Task Force Implementation of Strategic Reserve

April 1, 2019

10-year Adequacy & Flexibility study

Consultation Report

Technologies accounted in the flexibility study

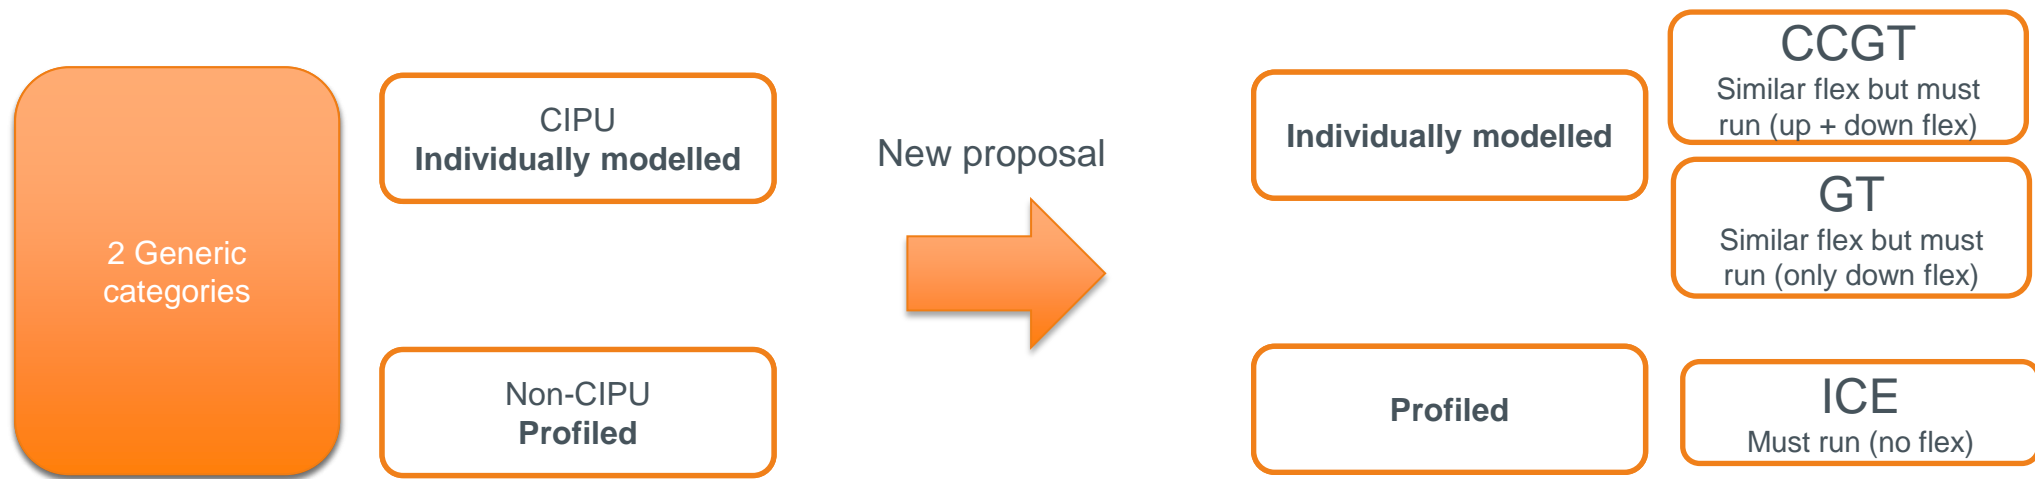
- Do the simulations take into account if the existing flexibles units are new or renovated [ACER]?
- Other categories of flexible capacity which can fill the structural block are also to be taken into account as source of flexibility (diesels, turbojets). Febeliec regrets that the diesel generators (and similar technologies) have not been introduced [CREG, FEBELIEC]?

A distinction between old / recent / new technologies is foreseen for CCGT and OCGT (as can be seen in the flexibility characteristics consulted)

Technology mix in the structural block are not defined yet, but a scenario with diesels and turbojets is foreseen in a sensitivity

The flexibility study will take into account the flexibility characteristics of each technology type which is used in the simulations

Turbojets and diesels will be treated as very flexible (fast flexibility and slow flexibility and only ramping flexibility when dispatched)
